**6711531  
FRC-EAST, CRANE  
REPLACEMENT AND  
MODERNIZATION**

**MCAS Cherry Point, NC  
AMENDMENT #0001**

This amendment is being issued to provide responses to the attached RFIs and updated drawing/spec sections as outlined in the continuation sheet attached.

DWG NO.	TITLE
PE-21753 4 of 6 Rev 1	WORK PLAN & NOTES – WORK SITES 3 & 4 – BUILDING 133, revised 3/22/19
PE-21753 5 of 6 Rev 1	PICTURES – WORK SITES 3 & 4 – BUILDING 133, revised 3/22/19
PE-21753 6 of 6 Rev 1	WORK PLAN, WORK NOTES AND PICTURES – WORK SITES 5 & 6 – BUILDING 137, revised 3/22/19

BUILDING:	133
SHOP:	VARIOUS
SIZE	CAGE CODE
<b>D</b>	<b>96916</b>
<b>PE-21753</b>	
SCALE:	AS NOTED
WO:	XA43284
SHEET	5 OF 6

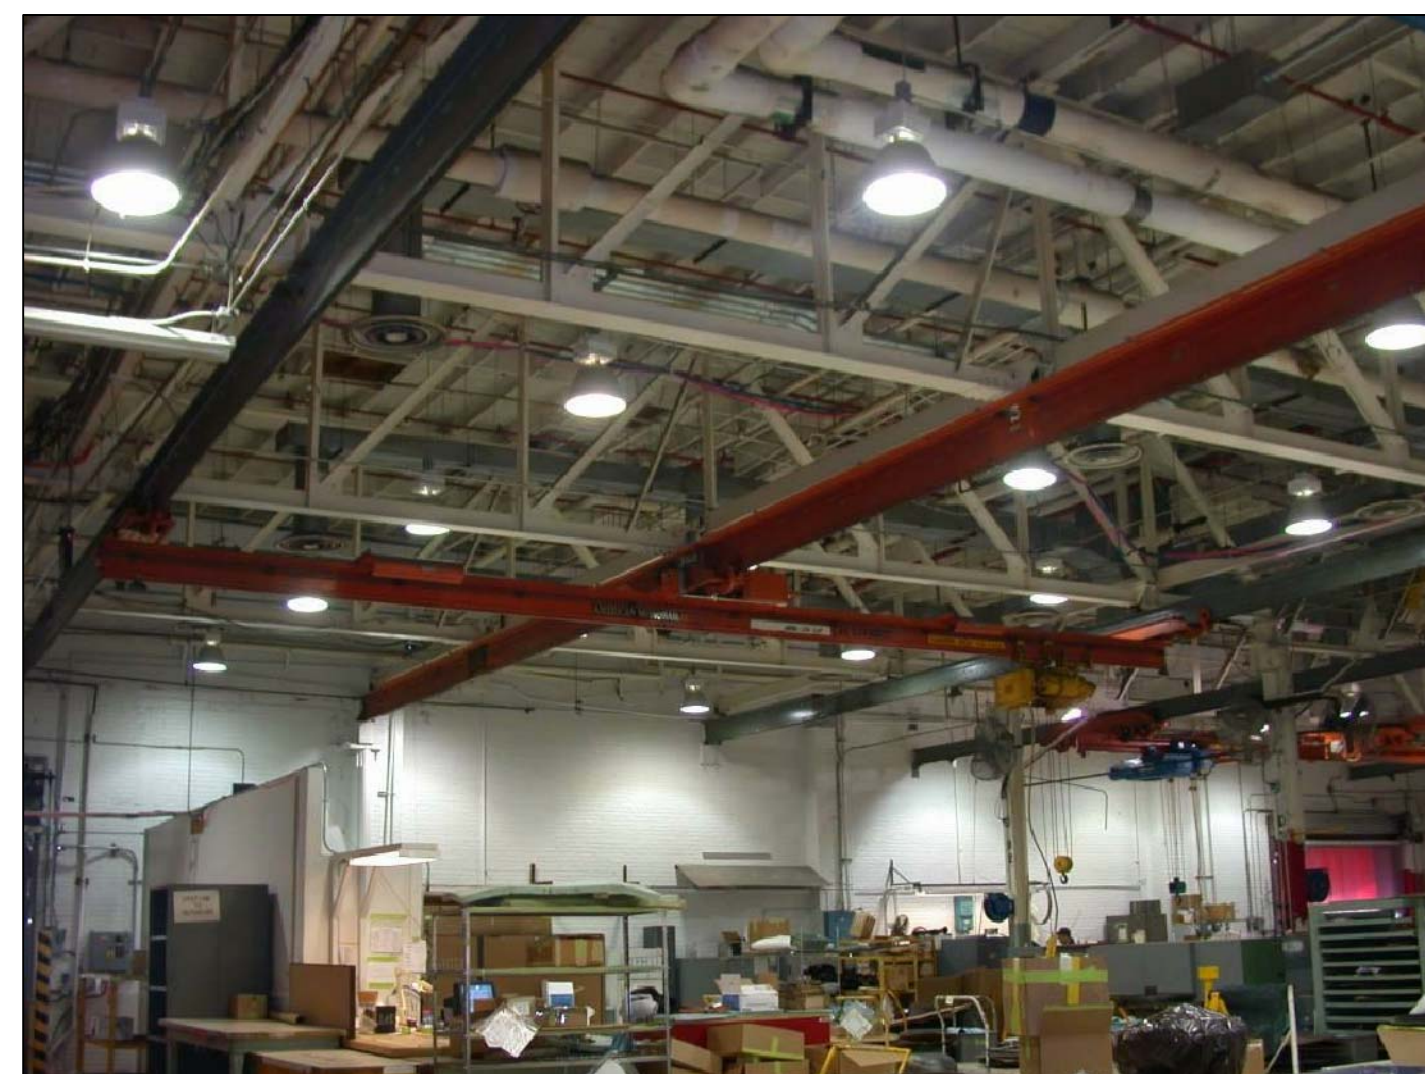
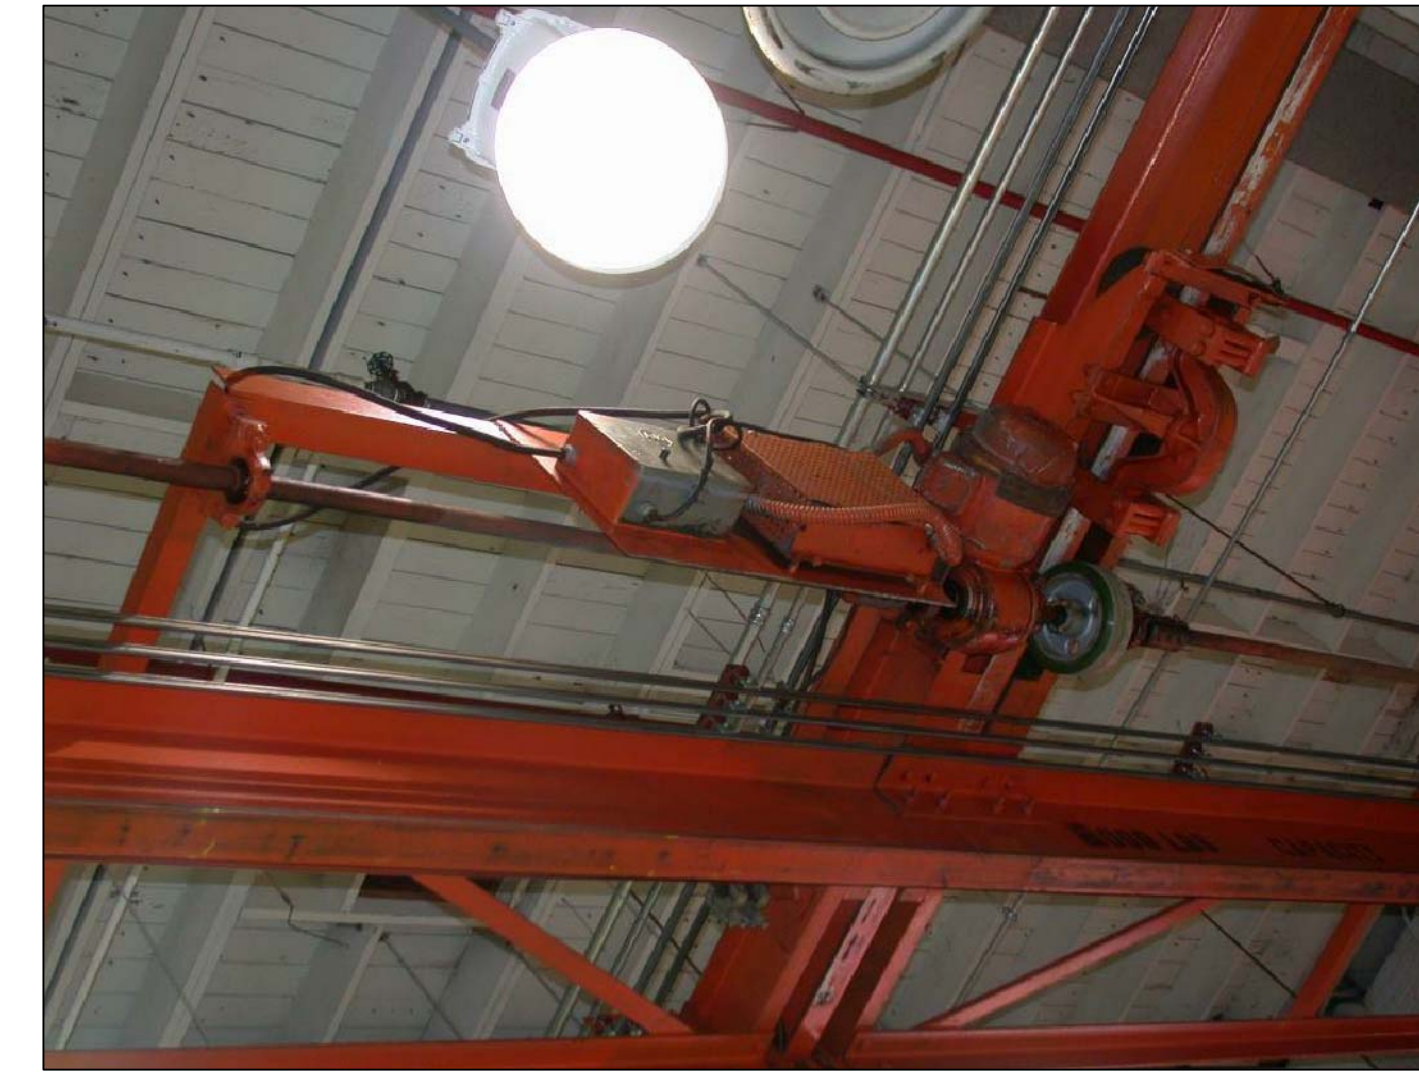
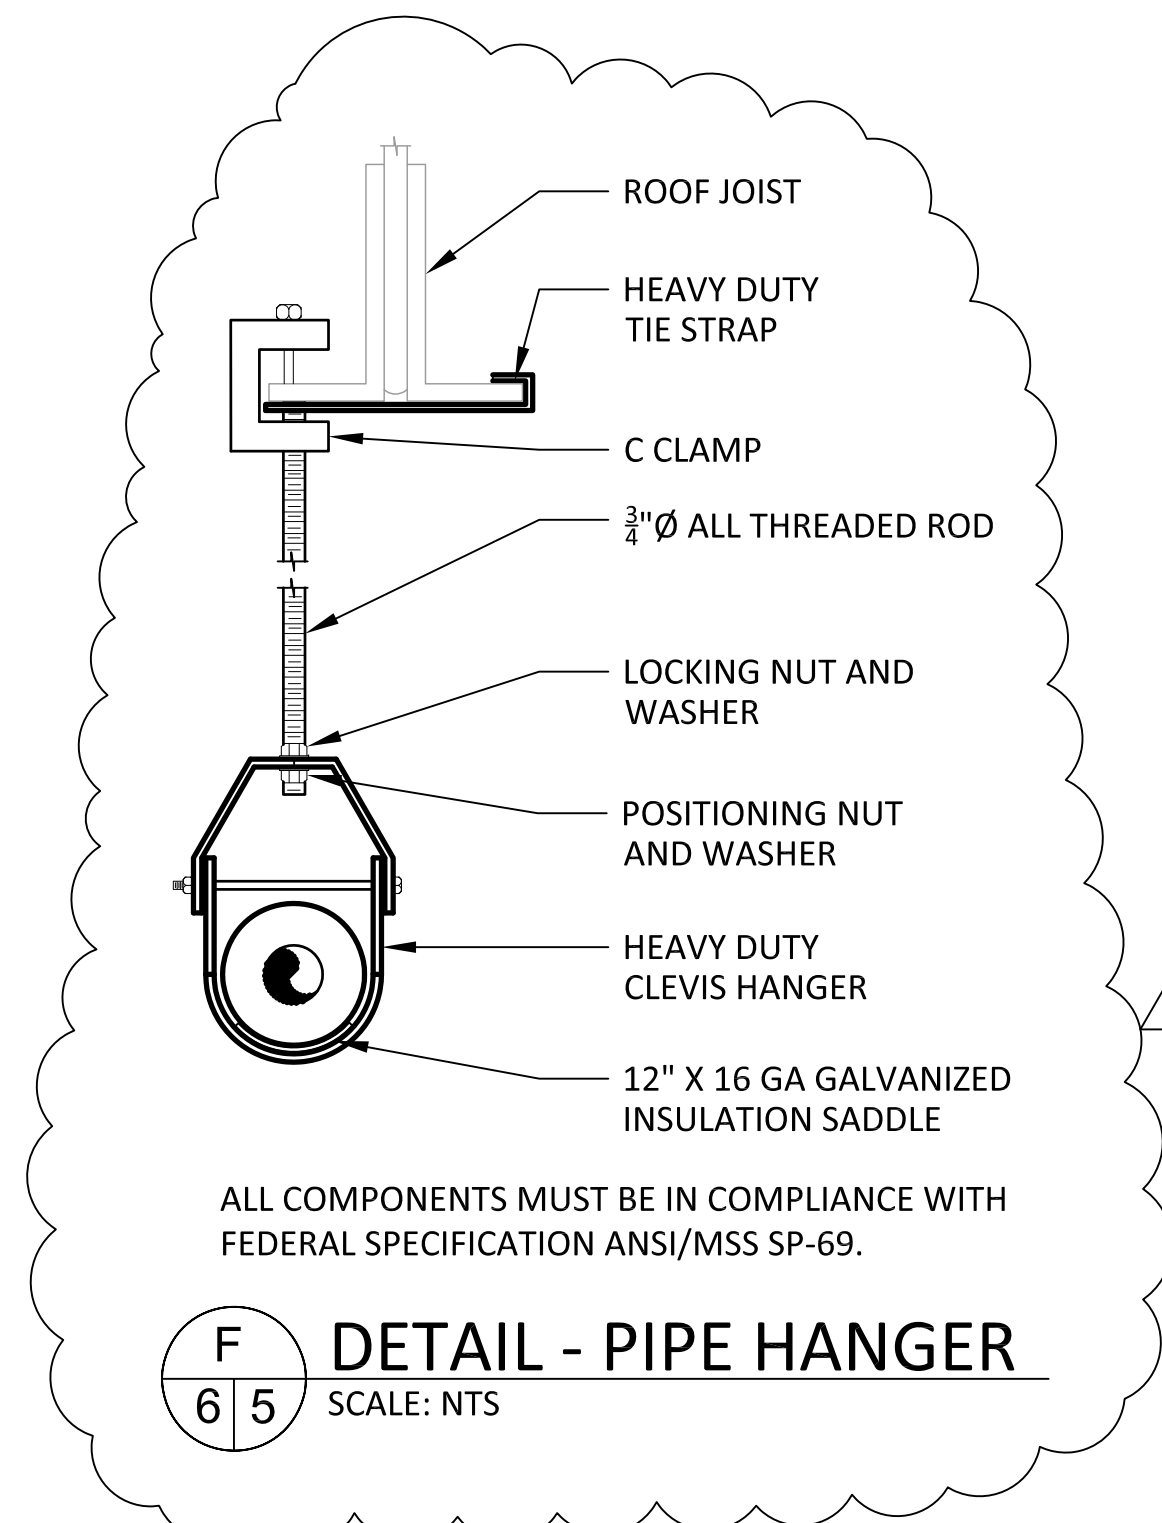
ZONE	REV	DESCRIPTION	DATE	APPR.
	A	DETAIL "F" ADDED	3/22/19
